**ADDENDUM TO THE MILL AREA
REMOVAL ACTION WORK PLAN
CHEVRON QUESTA MINE
SUPERFUND SITE**

Revision 1

Prepared for
Chevron Mining Inc.
Questa, New Mexico

September 27, 2018

UTILITY PLAN

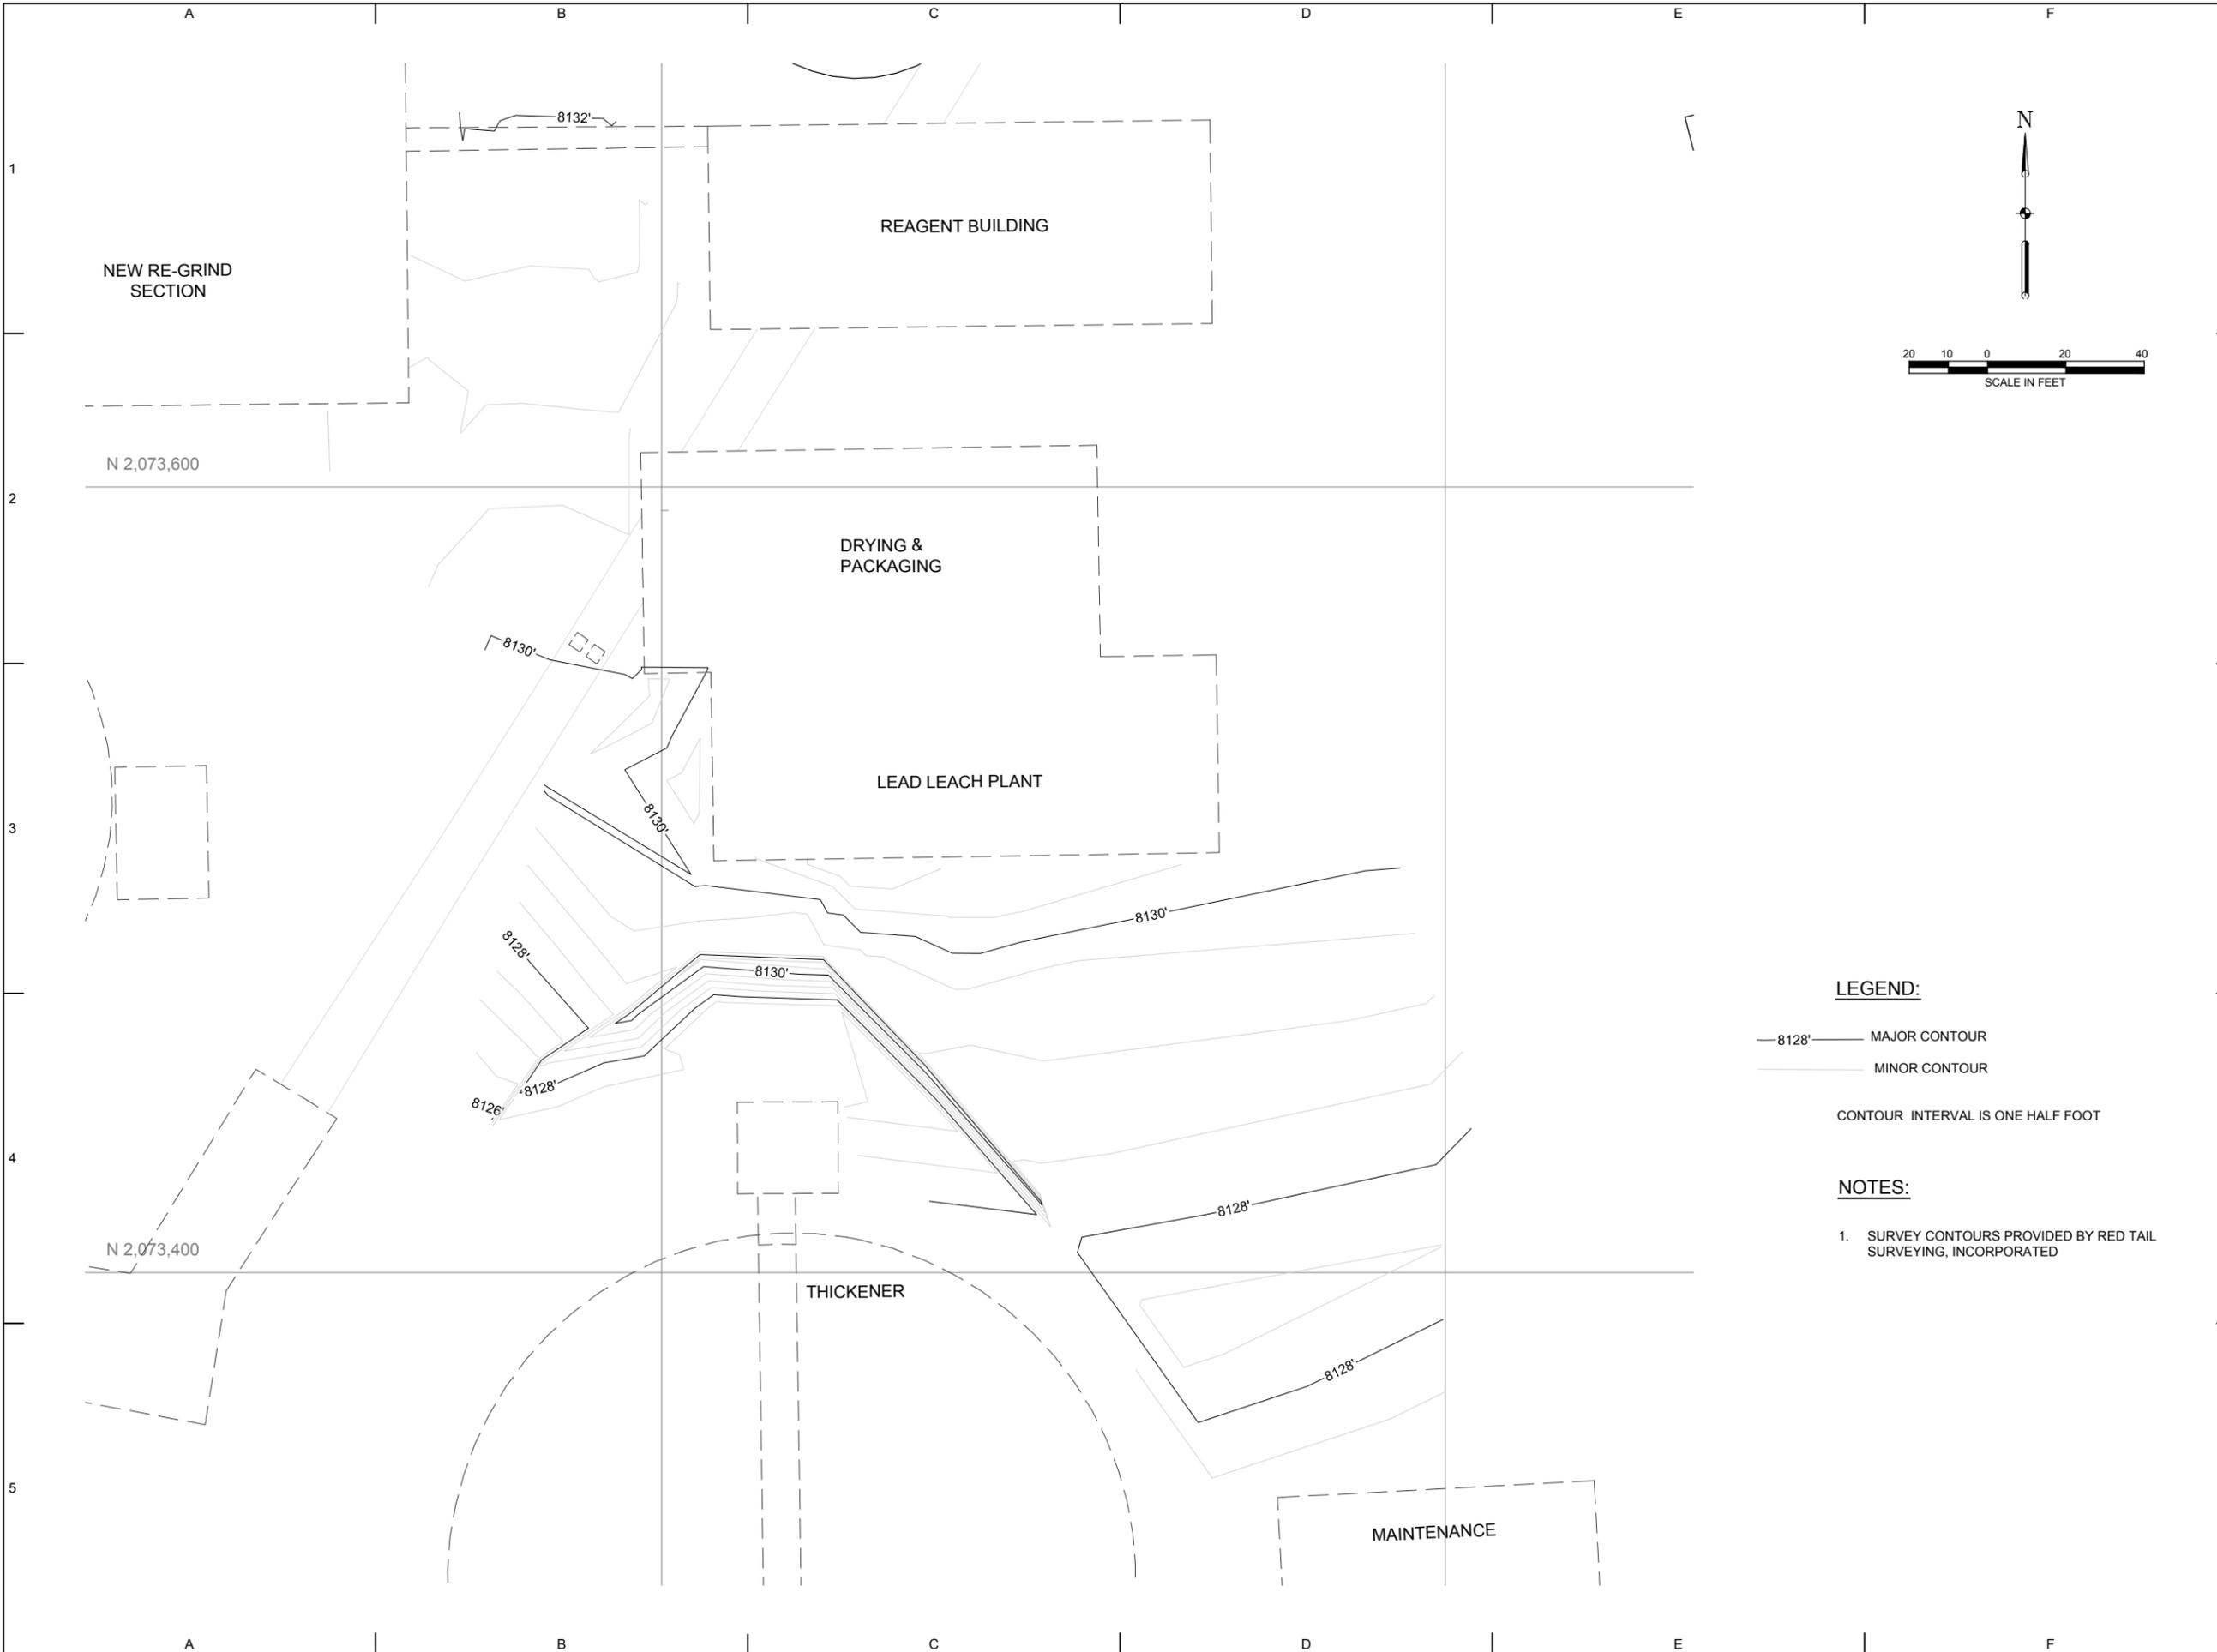
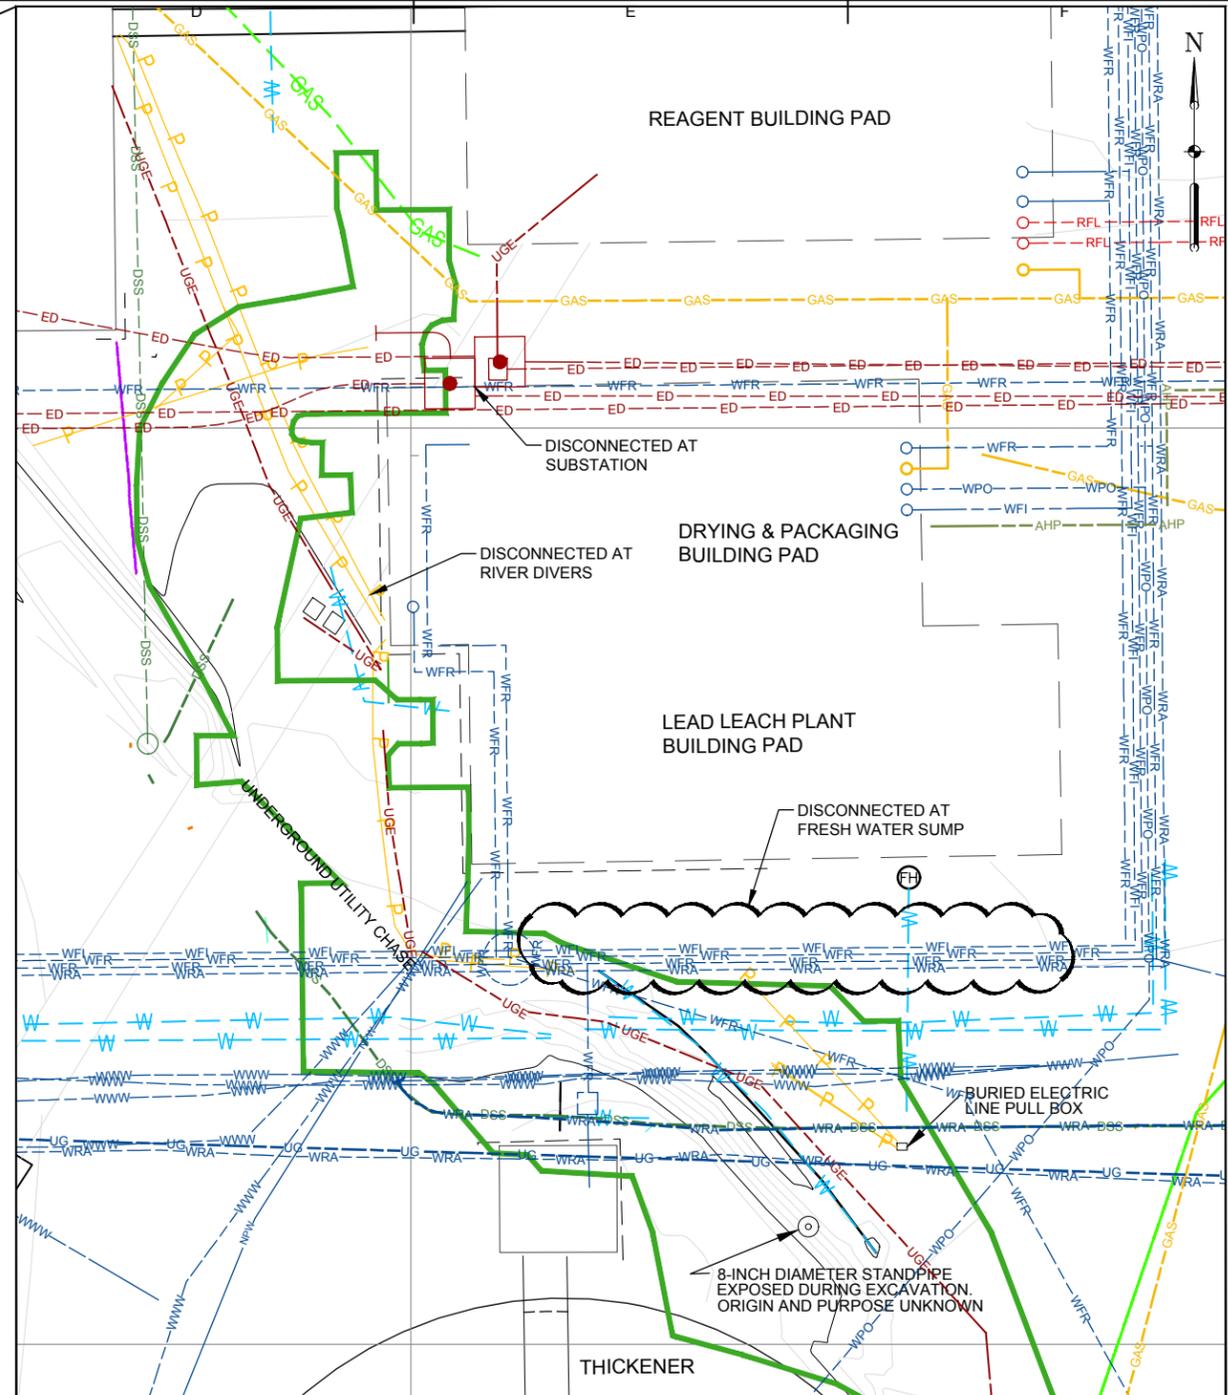
- Electric lines running in a northwest to southeast direction through the initial excavation to the west of the former Drying & Packaging Building (sample location Mill 050) and the north portion of the initial excavation to the southwest of the former Drying & Packaging Building with one electric line running almost due south along the west side of the southern portion of the initial excavation to the southwest of the former Drying & Packaging Building. Electric lines are estimated to be shallower than 3 ft below ground surface (bgs). Drawing C-2 indicates that these electric lines were disconnected at River Divers during the D&D project.

- Gas line running northwest to southeast along the west side of the northern initial excavation (sample locations Mill 139 and Mill 135) to the southwest of the former Lead Leach Plant. This gas line also runs into the southern initial excavation (sample location Mill 134) to the southwest of the former Lead Leach Plant.

- Electric line running north to south to the east of the initial excavation at the southwest corner of the former Lead Leach Plant (sample location Mill 134). Drawing C-2 indicates that this electric line was disconnected at the substation during the D&D project.

EXISTING
CONDITIONS AND
2018 EXCAVATION
PLAN

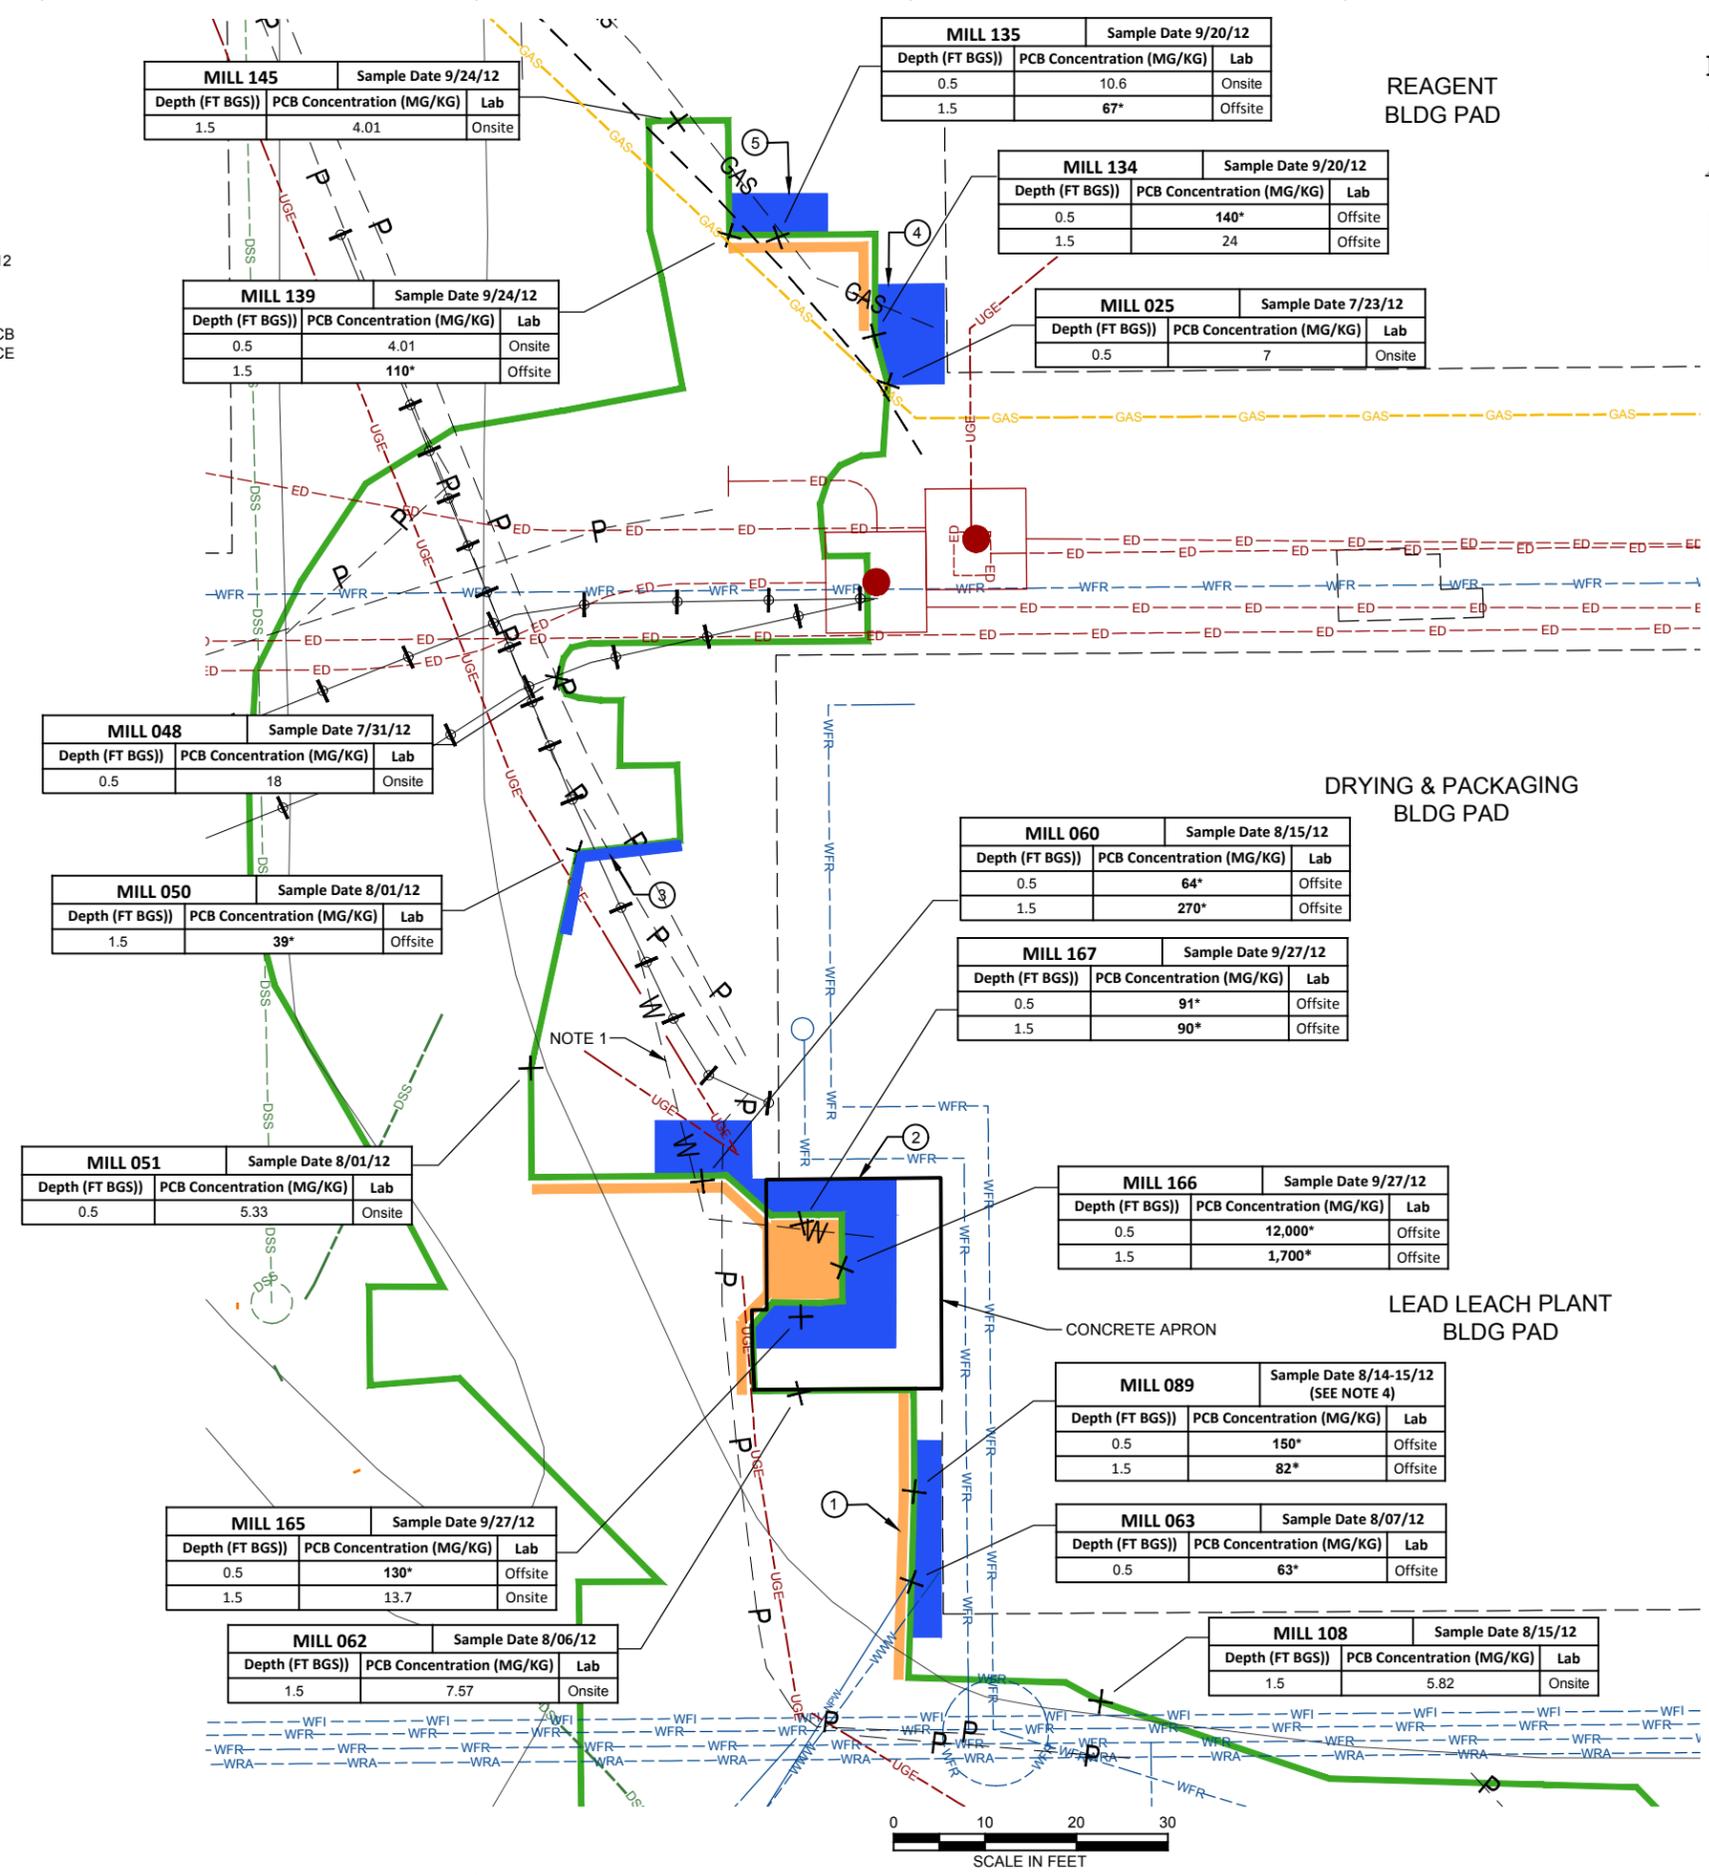
In accordance with the 2012 approved work plan Section 3.1.1, the 2018 work plan addendum is revised as follows:

The target depth of the excavations shown in Drawing C-1A will be three feet below ground surface (bgs); however, if sampling confirms PCB concentrations ≥ 25 mg/kg below three feet bgs, additional excavation and sampling may be required. Excavation activities will continue until either PCB concentrations are < 25 mg/kg or the maximum excavation depth of four feet is achieved.
